Informal document No. GRE-54-8
(54th GRE, 5-8 April 2005,
agenda item 2.)

PROPOSAL FOR DRAFT AMENDMENTS TO REGULATION No. 10

(UNIFORM PROVISIONS CONCERNING THE APPROVAL OF VEHICLES
WITH REGARD TO ELECTROMAGNETIC COMPATIBILITY)

Appendix 2

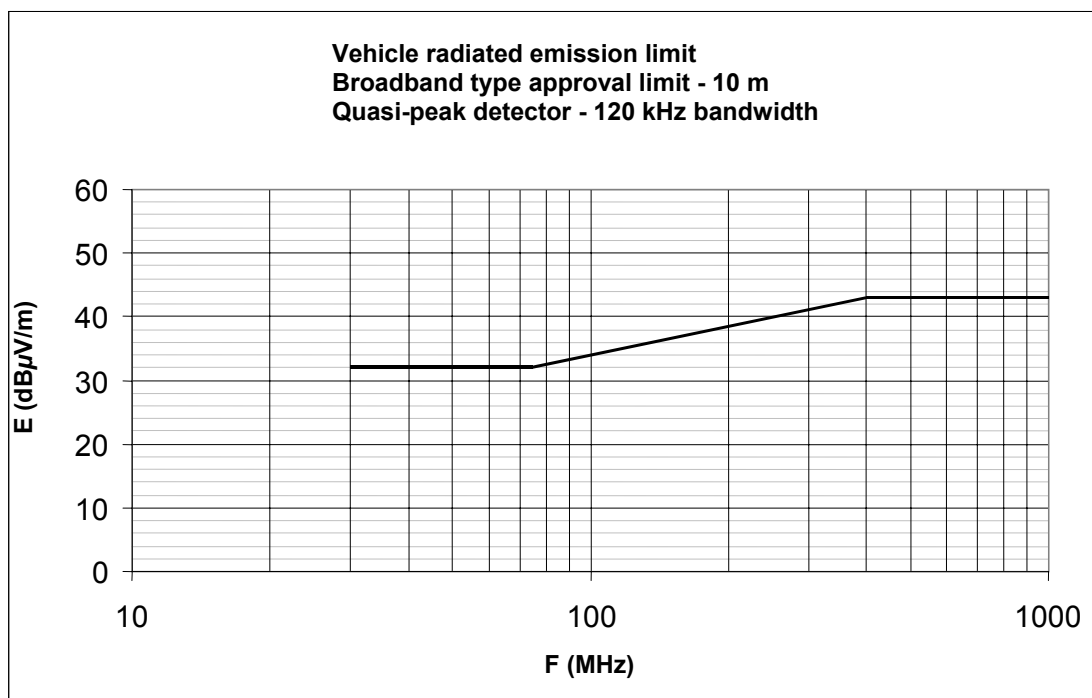
Appendices 2,3,4,5,6,7 are amended to read:

Limit E (dBμV/m) at frequency F (MHz)		
30 - 75 MHz	75 - 400 MHz	400 - 1000 MHz
E = 32	E = 32 + 15,13 log (F/75)	E = 43

Appendix 3

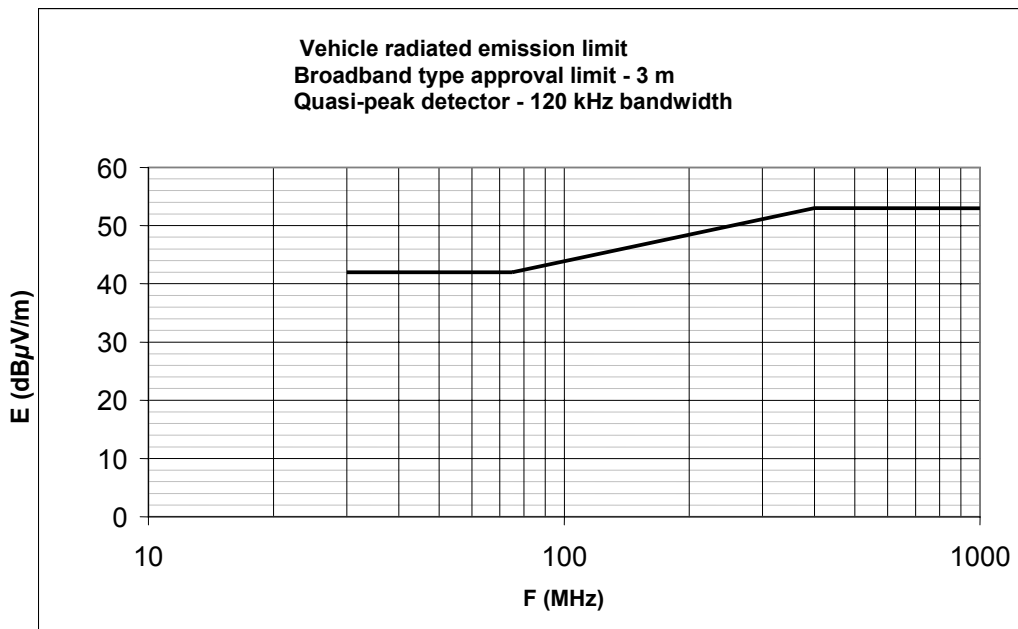
Limit E (dBμV/m) at frequency F (MHz)		
30 - 75 MHz	75 - 400 MHz	400 - 1000 MHz
E = 42	E = 42 + 15,13 log (F/75)	E = 53

Appendix 4

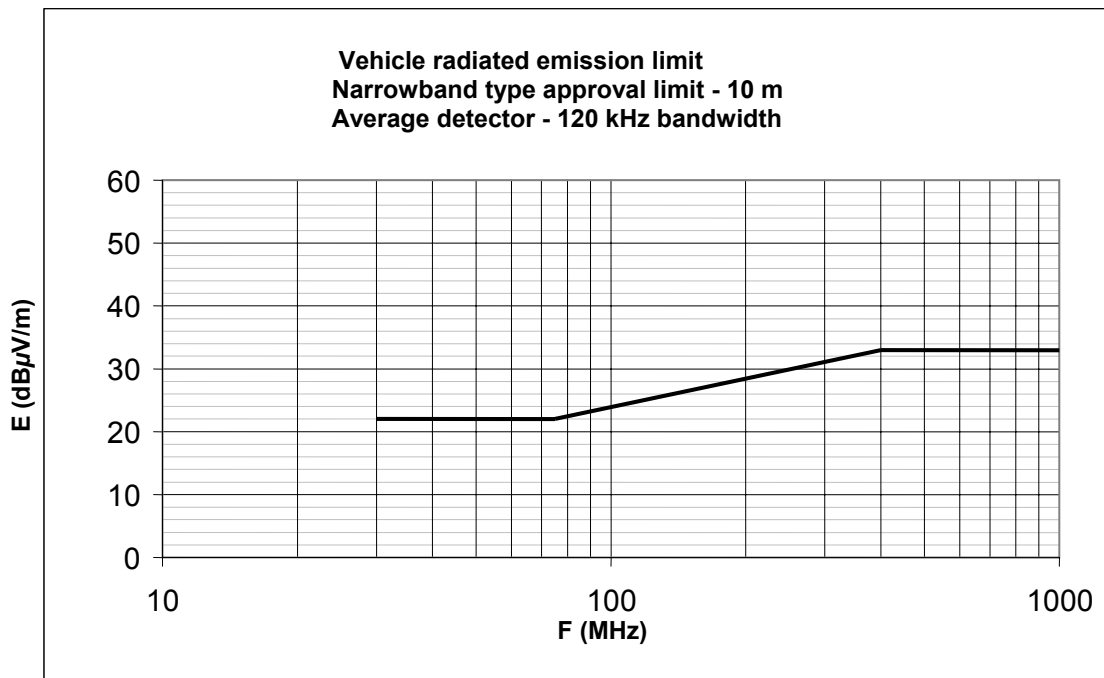
Limit E (dBμV/m) at frequency F (MHz)		
30 - 75 MHz	75 - 400 MHz	400 - 1000 MHz
E = 22	E = 22 + 15,13 log (F/75)	E = 33

Appendix 5

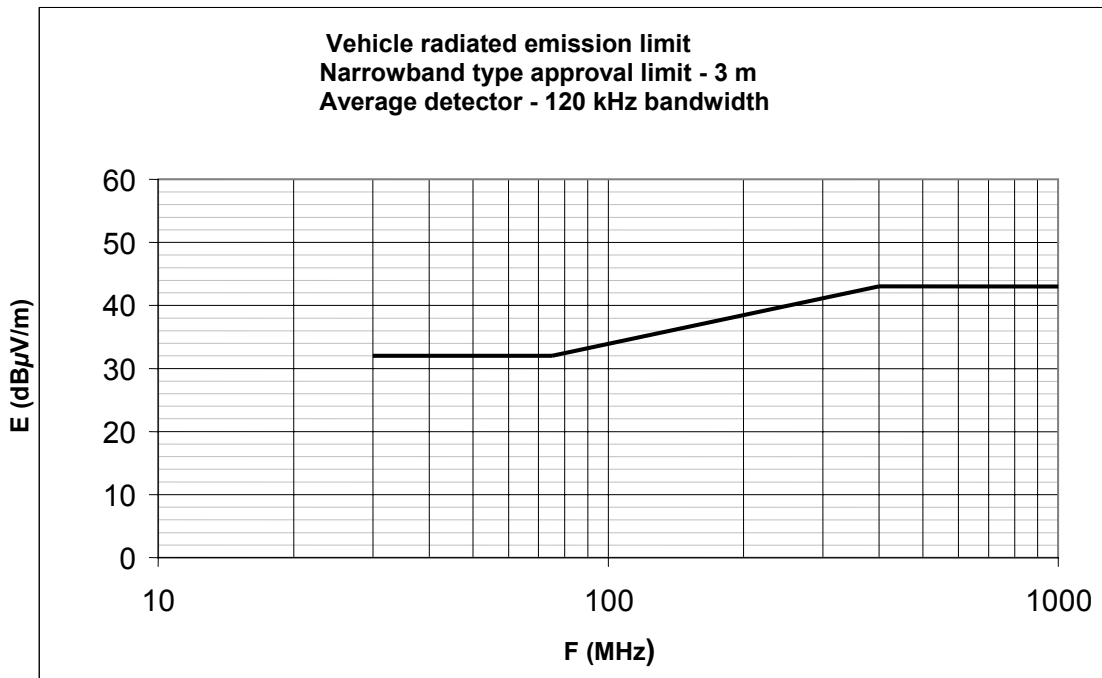
Limit E (dBμV/m) at frequency F (MHz)		
30 - 75 MHz	75 - 400 MHz	400 - 1000 MHz
E = 32	E = 32 + 15,13 log (F/75)	E = 43

Appendix 6

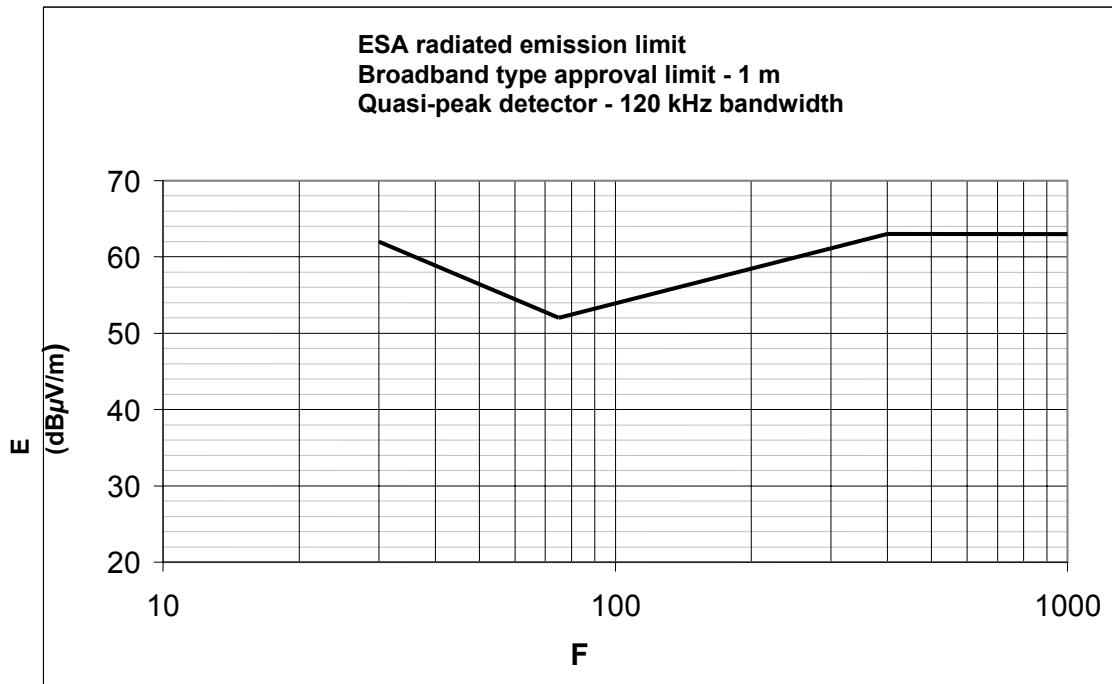
Limit E (dBμV/m) at frequency F (MHz)		
30 - 75 MHz	75 - 400 MHz	400 - 1000 MHz
$E = 62 - 25,13 \log (F/30)$	$E = 52 + 15.13 \log (F/75)$	$E = 63$

Appendix 7

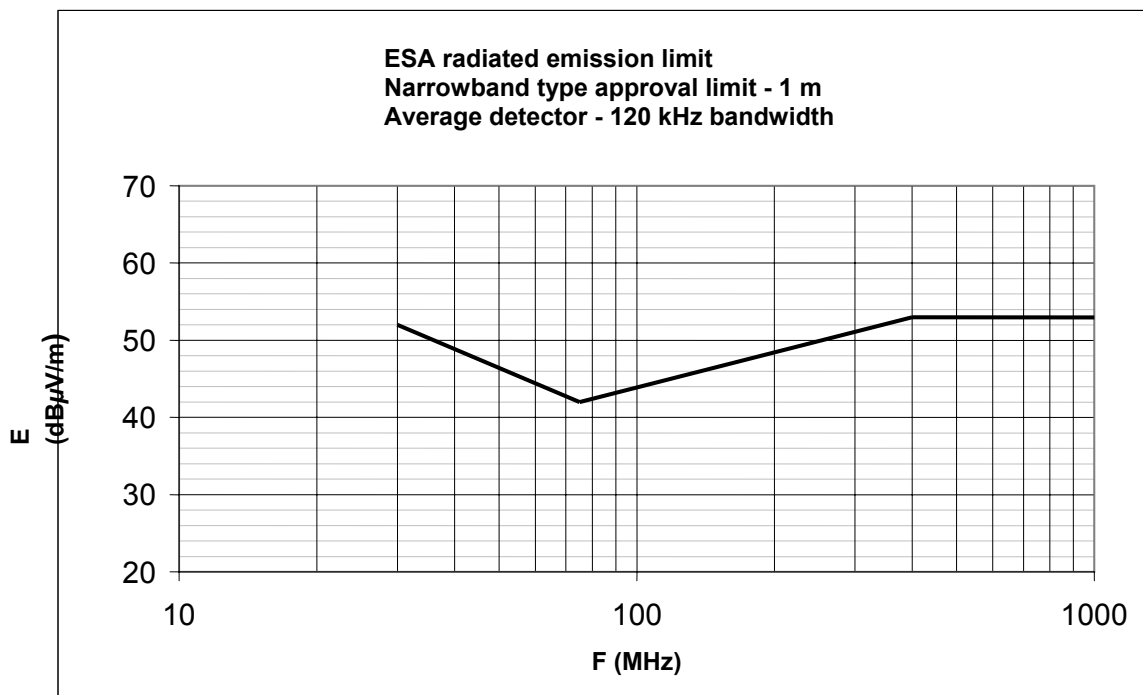
Limit E (dBμV/m) at frequency F (MHz)		
30 - 75 MHz	75 - 400 MHz	400 - 1000 MHz
$E = 52 - 25,13 \log (F/30)$	$E = 42 + 15.13 \log (F/75)$	$E = 53$

Model A

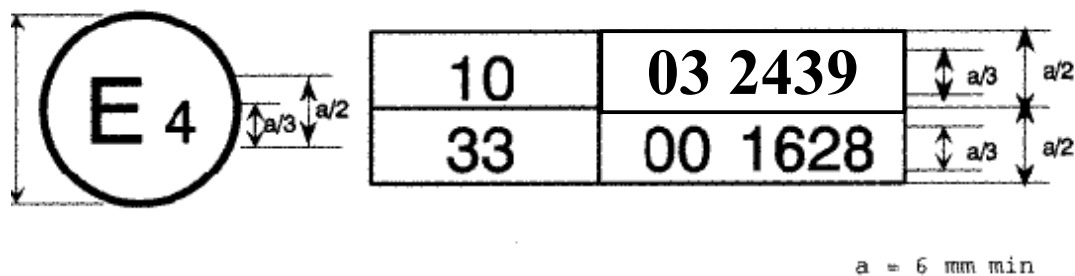
Annex 1 is amended to read:

The above approval mark affixed to a vehicle or ESA shows that the vehicle type concerned has, with regard to electromagnetic compatibility, been approved in the Netherlands (E 4) pursuant to Regulation No. 10 under approval No. 022439. The approval number indicates that the approval was granted according to the requirements of Regulation No. 10 as amended by the 03 series of amendments.
